Capitol Accessibility Photos

Jillian Schaible

Brynchild Haugland

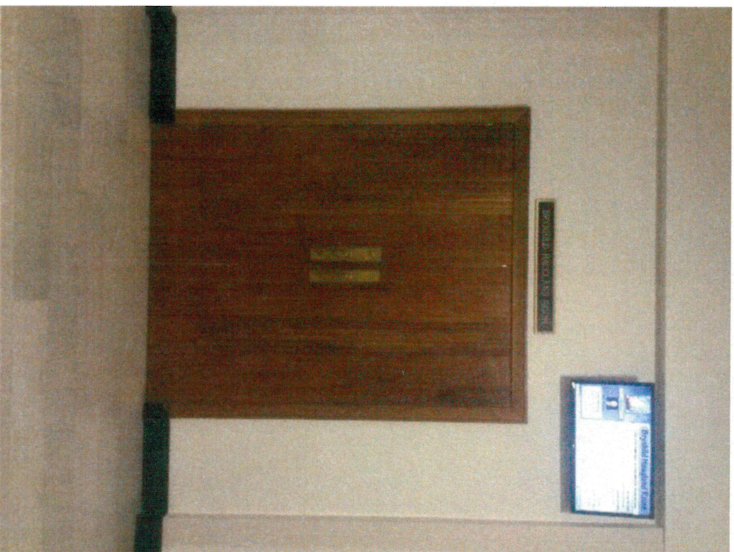
- Both TVs outside both entrances are too high
- Wheelchair elevator is located here

Brynchild Haugland second entrance

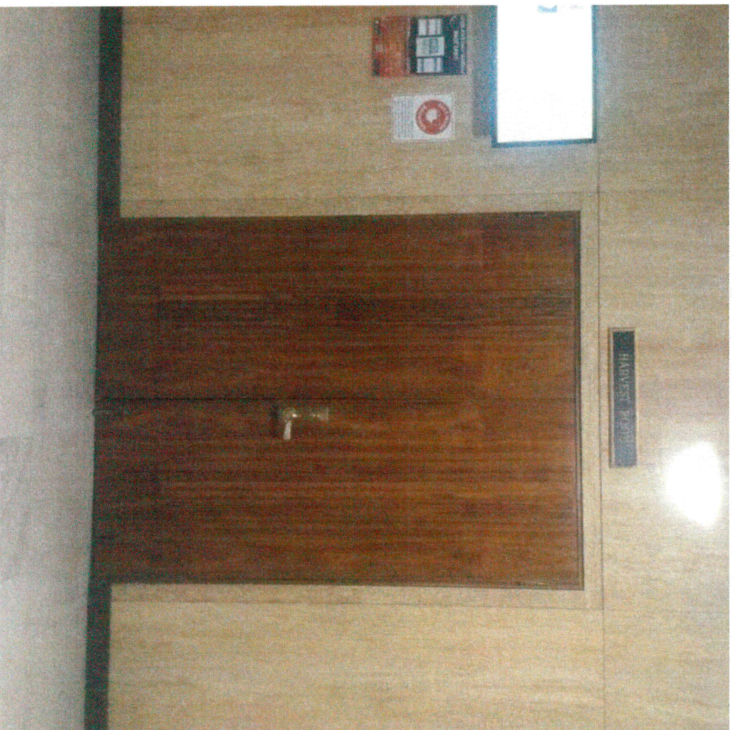
- TV height too high

Horseshoe Rooms

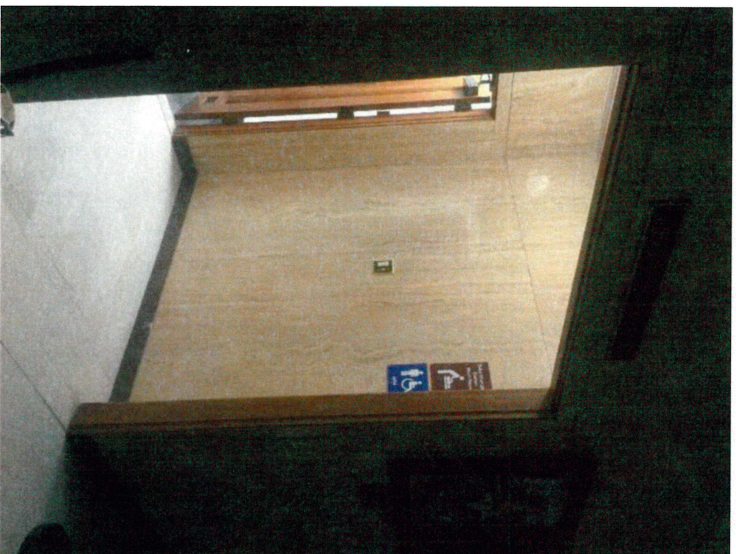
- Can the doors remain unchanged?
- What about having a doorbell outside with an indicator light? When it goes off someone could open both doors
- Can we stream committee hearings on these TVs?
- All TVs appear to be the same height; no changes made to doors

Ground Floor Men's Bathroom A

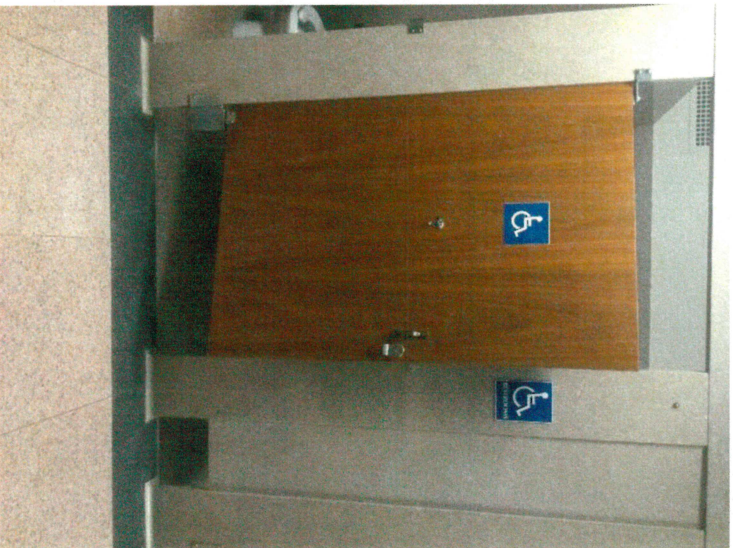
- Accessible entrance
- All accessibility signage should be at the same level everywhere

Ground Floor Men's Bathroom B

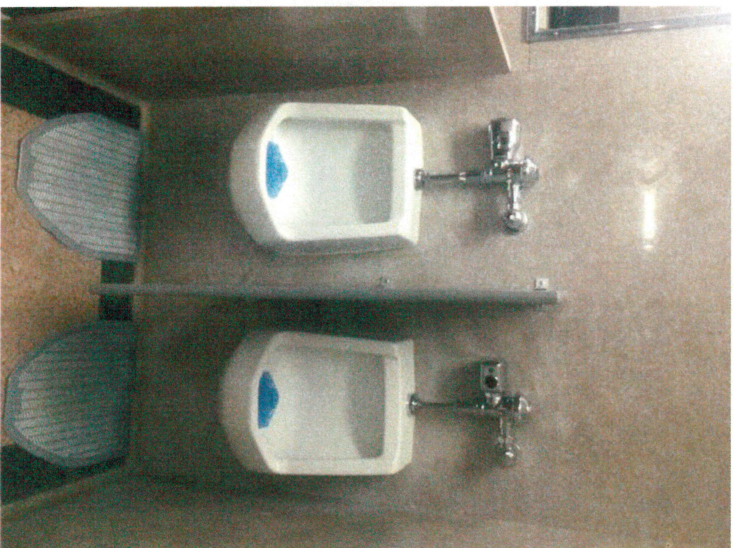
- No accessibility signage

Ground Floor Ramp

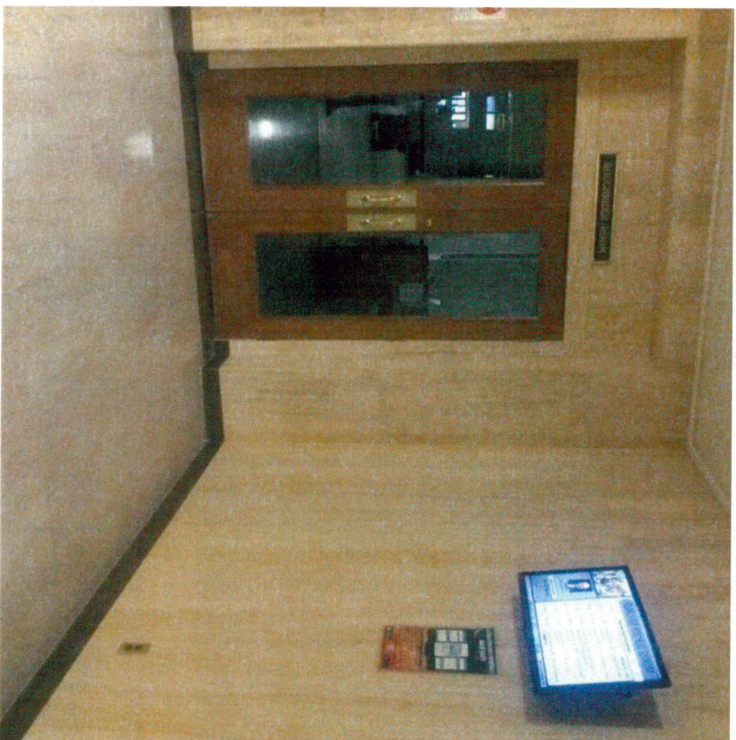
- The architect said this was not ADA compliant somehow...

Small Elevator keypads – 37 total

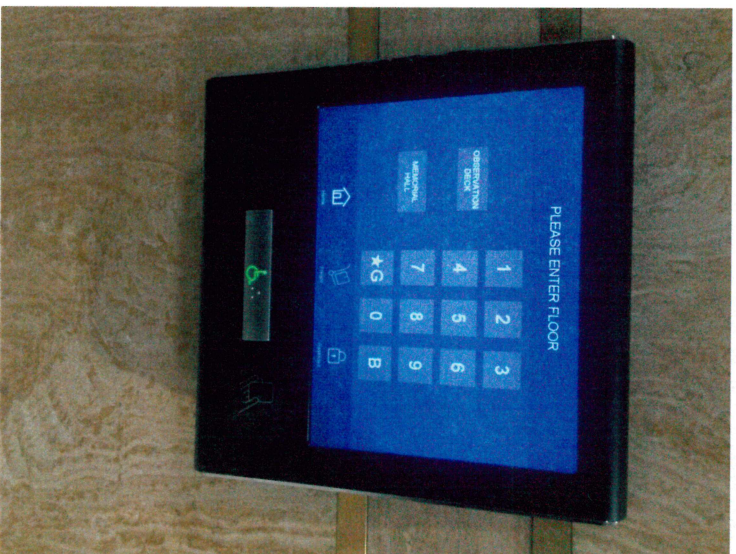
- Who manufactures these?
- When were they installed?
- Do they get tested to ensure they are working properly?
- If so, how often?
- What happens if one breaks?
- Can pressure sensitivity, volume, tone, reaction speed, voice speed be changed?
- Post instructions on how to operate?

Large Elevator keypads – 2 – Ground floor

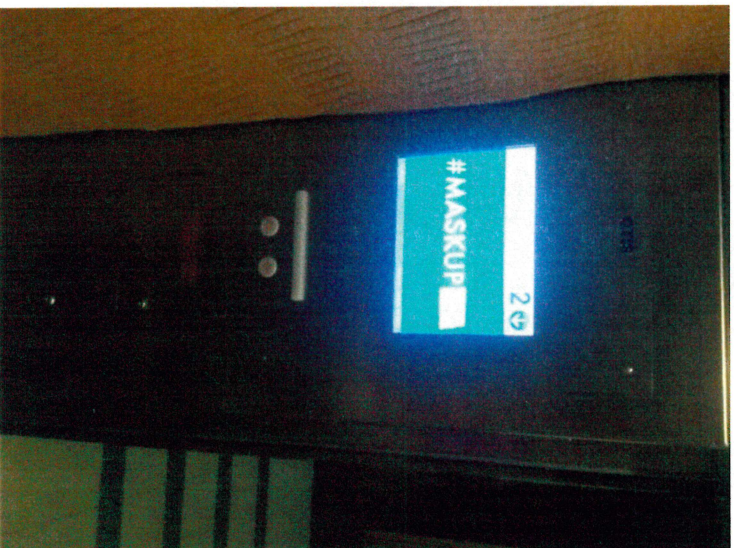
- Why are these different from the other 37?
- Same questions apply regarding the small elevator keypads

Executive Elevator Screens A, B, C, D

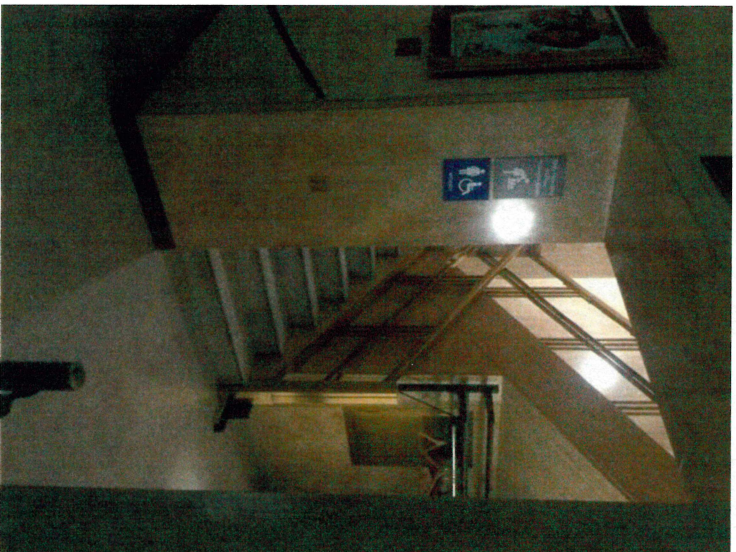
- Can these be programmed to better assist visually/hearing impaired?
- Who programs them?

Ground Floor West Door

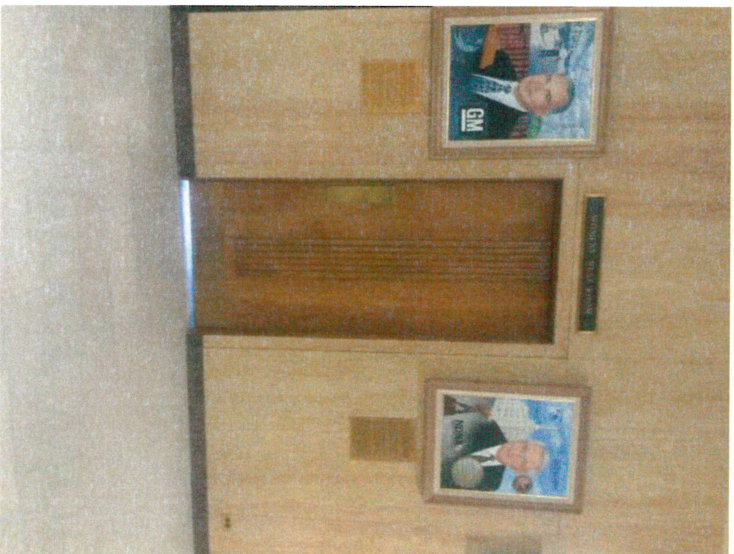
- Automatic door
- Why isn't there one on the Judicial wing entrance/exit door?

Ground Floor Women's Bathroom

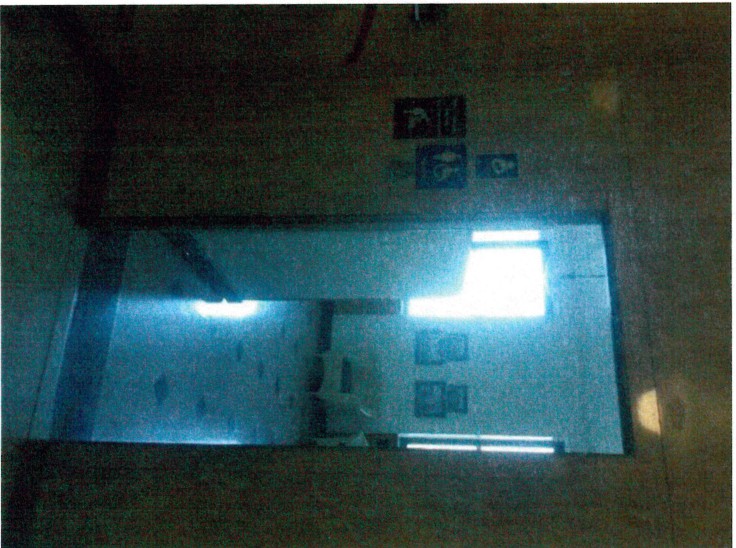
- Why is the signage inside the second door?
- Signage is too high

2nd Floor Offices

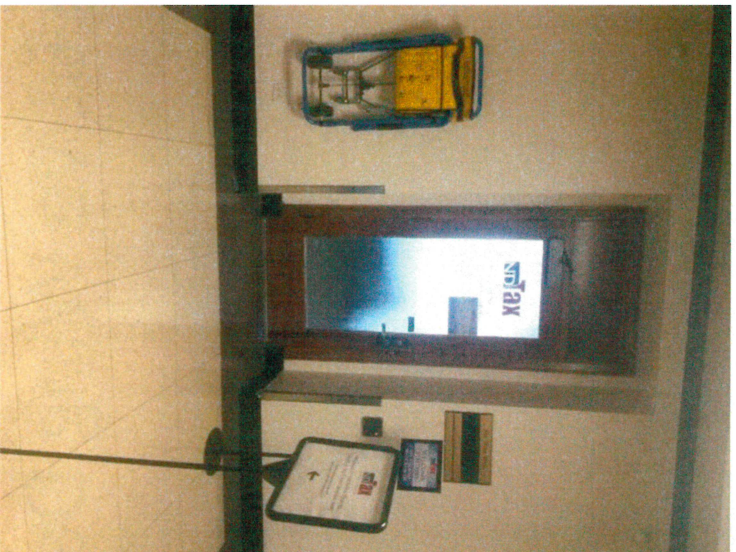
- Why are there not two doors here?

Executive Wing Department Floors 3-18

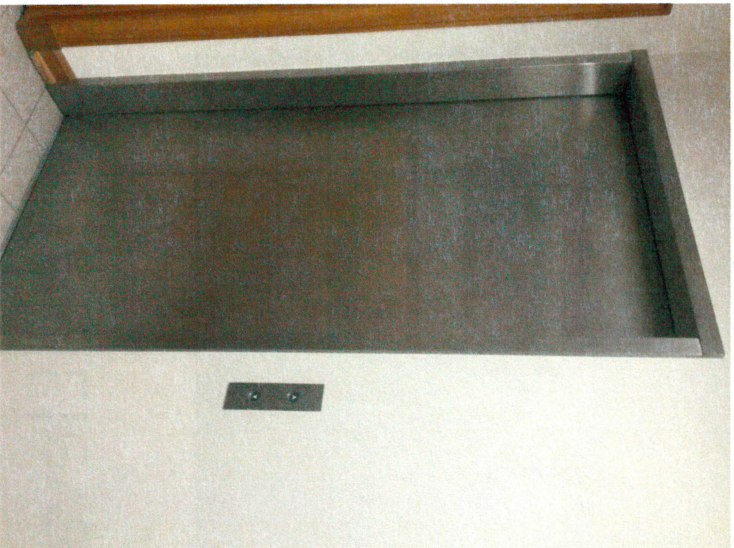
- Trash can blocking keypad access
- This occurs on multiple floors

Judicial Wing – All “accessible” stalls

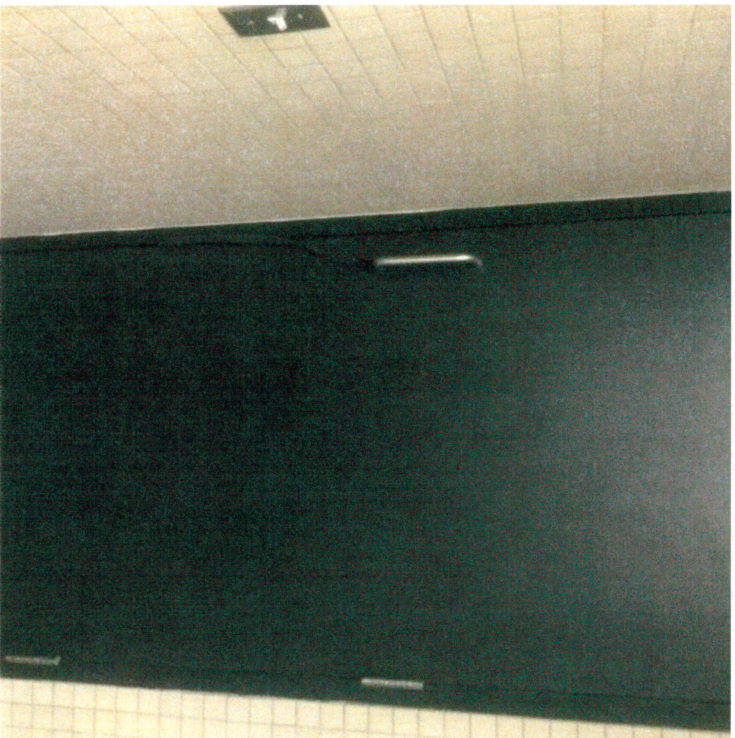
- Original grab bars
- Bar length should be longer so person won't be blocking toilet before transfer
- Vertical bar would help with this also
- All “accessible” judicial wing stalls have similar set up
- Most, if not all also have a coat hanger close to door lock, which could be a safety hazard and should be on the back of the stall door at an accessible height

Judicial Wing – 1st and 2nd Inside bathrooms

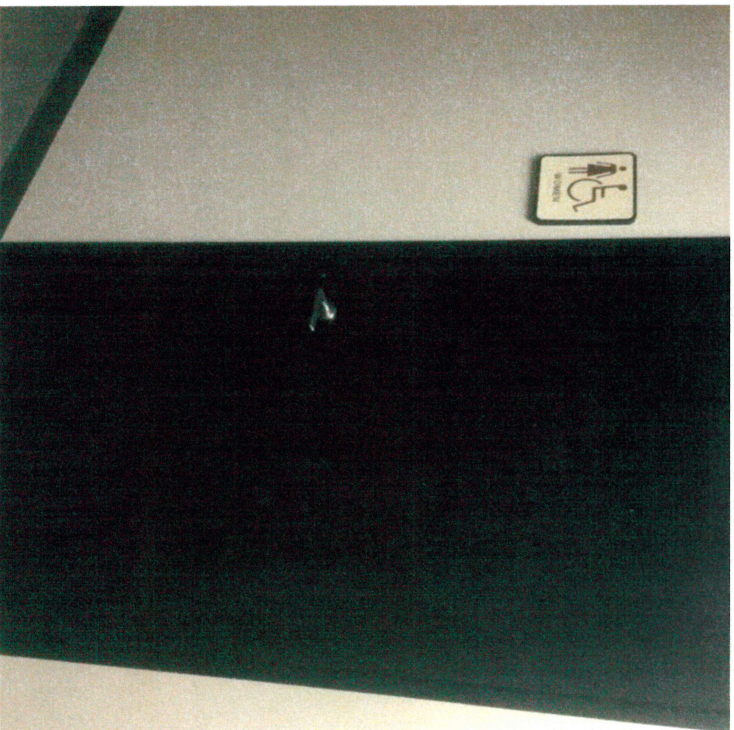
- Difficult to open door with strap in a manual or powered wheelchair
- Need to reverse until there's enough room while still holding strap and driving chair
- How does a person hold the door open as far as they can, AND move through the door unassisted?
- Judicial wing 1st floor men's and women's, 2nd floor women's, not men's

Judicial Wing – Hallway Bathrooms

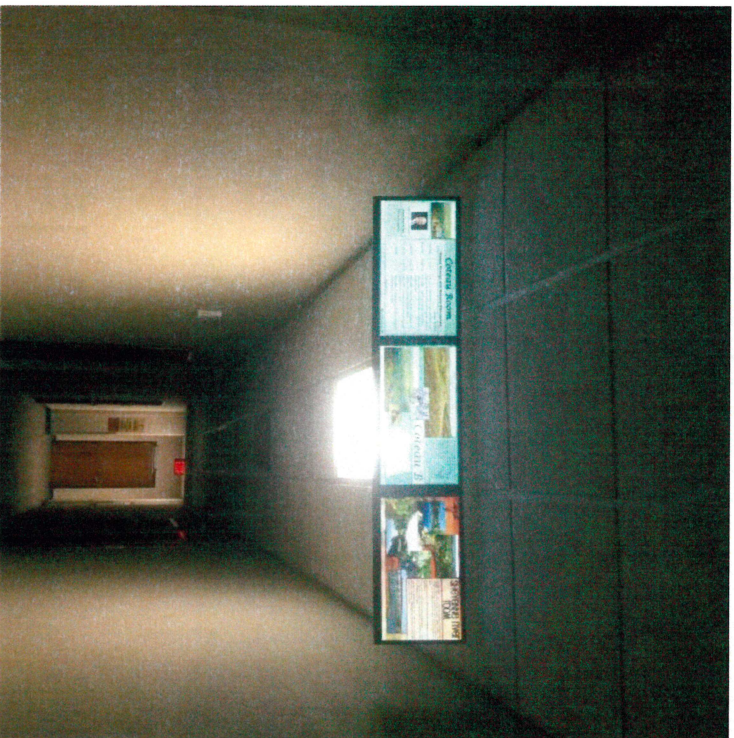
- Door #2
- Occurs with all bathrooms inside Judicial wing hallways
- Trash can obstacle
- Easy to push door going in, may be difficult to open coming out due to counter location

JWing – Ground Floor

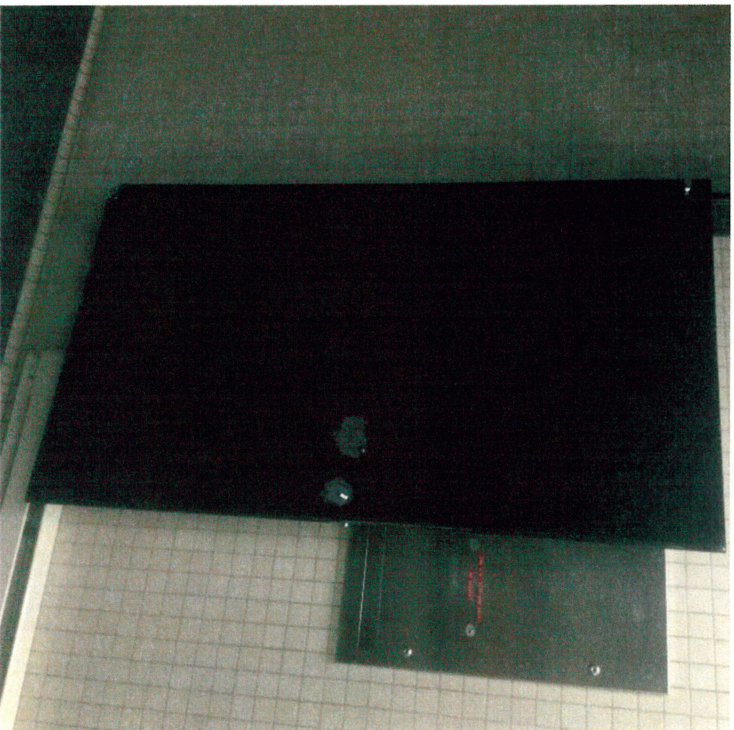
- Move soap to paper towel dispenser to make it easier to reach
- Cover all sink plumbing
